Planning Rationale & Urban Design Brief

Site Plan Control Application

Navan Residential and Commercial Block 15 2983 Navan Road

3.5 Response to City Urban Design Comments

Figure 5 City of Ottawa Official Plan Schedule A showing subject property approximate location within the Suburban area.

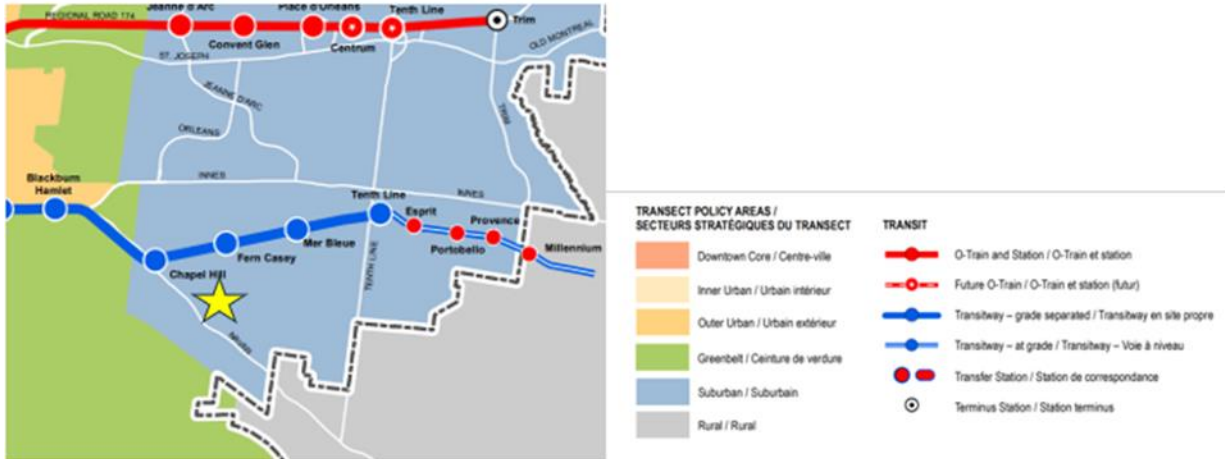
City Comment: If this site is located outside the greenbelt, a shadow analysis will be required.

JLR Response: As shown in Figure 5, the subject property is outside of the Greenbelt. A Shadow Analysis is provided.

Figure 13 Site view from corner of Brian Coburn Blvd and Navan Road.

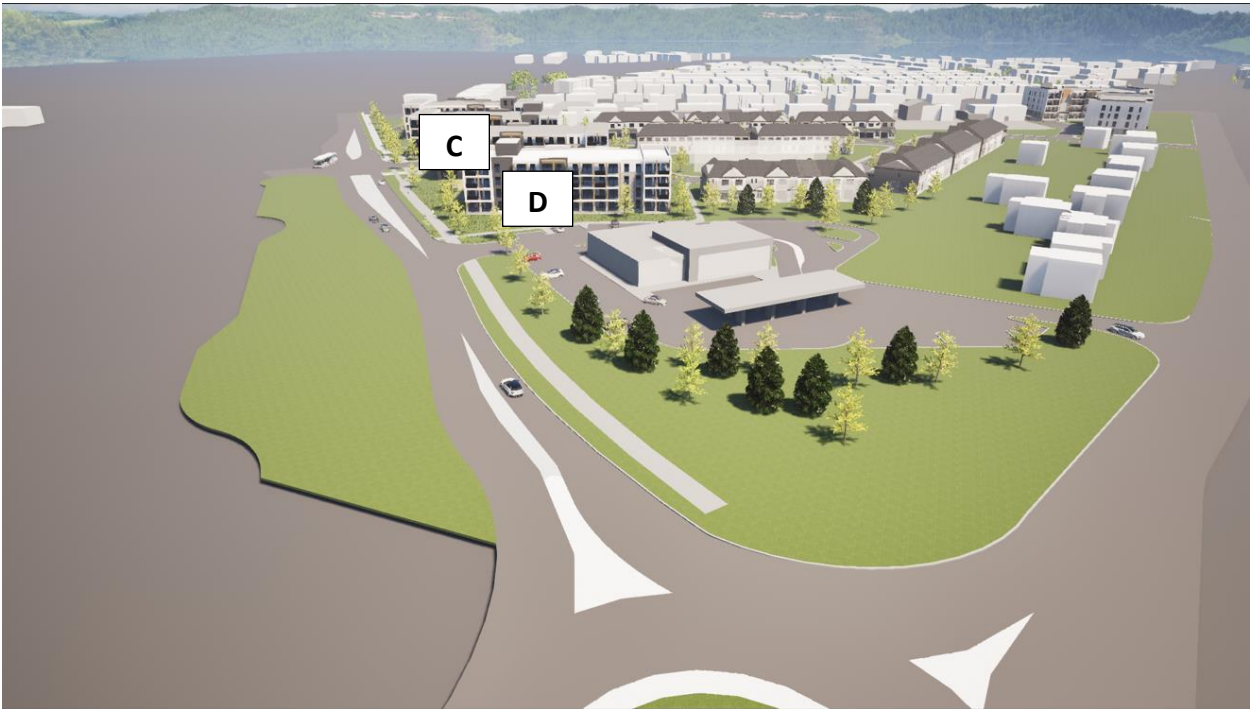
City Comment: We recommend further detail be provided about the low-rise apartments to better understand their relationship to the surrounding buildings and properties.

JLR Response: See Figures 12-20 provide the detail of the low-rise apartments and how they are integrated into the surrounding area. These plans also show how the design provides an appropriate face to Brina Coburn Blvd.

Figure 21 Block 15 Landscape Plan

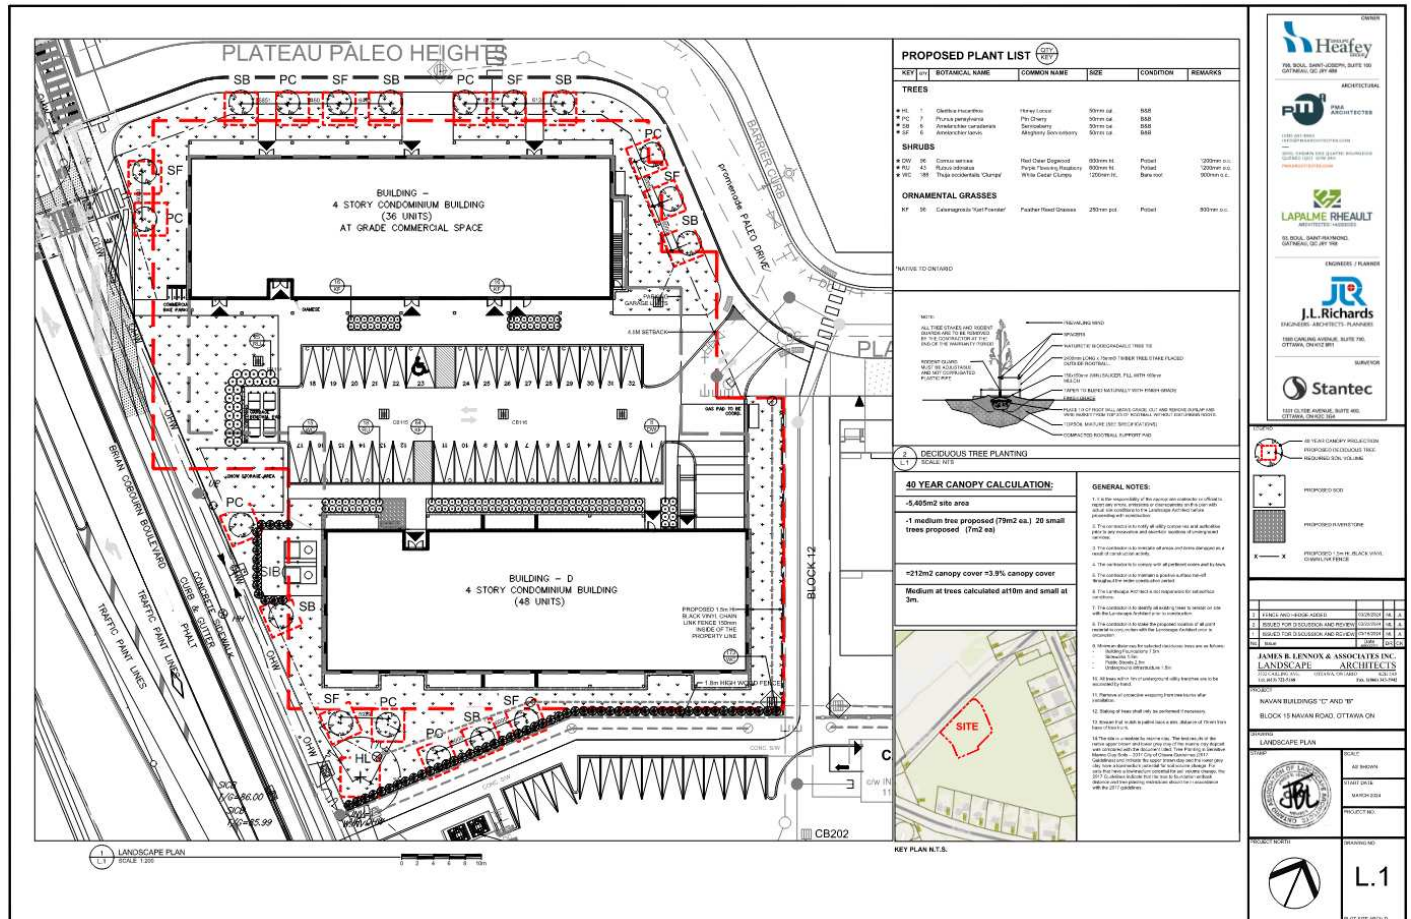
City Comment: We recommend additional landscaping detail be provided around the low-rise apartments to better understand how the buildings relate to their context.

JLR Response: Additional landscaping has been provided as shown in the landscaping plan (Figure 21). Refer to above renderings and Landscape Plan for further details.
